STATE OF HAWAII
DEPARTMENT OF TRANSPORTATION
HIGHWAYS DIVISION

ADDENDUM NO. 1

HANA HIGHWAY IMPROVEMENTS

PROJECT NO. 360AB-02-00

PAVEMENT SECTION FOR ASPHALT CONCRETE FOR PULL-OUT AREAS, MIX NO. IV
NOT TO SCALE

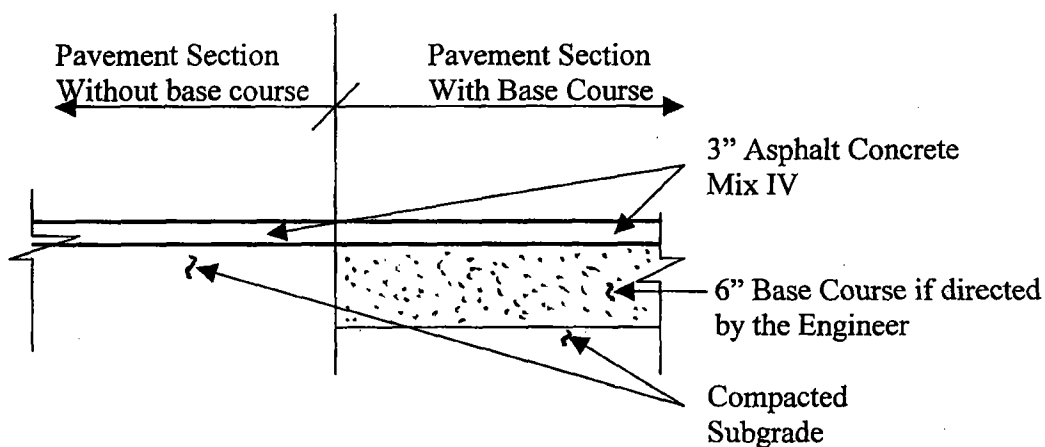
1. Replace page 401-21a dated 7/14/03 with the attached page 401-21a dated 10/29/03.

- NOTES:
1. The above pavement section applies to paving roadway shoulder pullout areas at Mile Post Nos. 4.32, 5.08, 5.10, 6.10, 6.20, 6.60, and 7.00.
 2. Paving limits at each of the above Mile Post locations will be determined by the Engineer. Pavement areas will vary from 200 to 400 square feet per location.
 3. If 90% minimum compaction of the AC Pavement cannot be achieved on compacted subgrade areas, the Contractor shall notify the Engineer and inform him of the steps taken to achieve compaction. The Engineer may accept the AC Pavement in-place and pay for accepted work at 100% of the contract unit price.
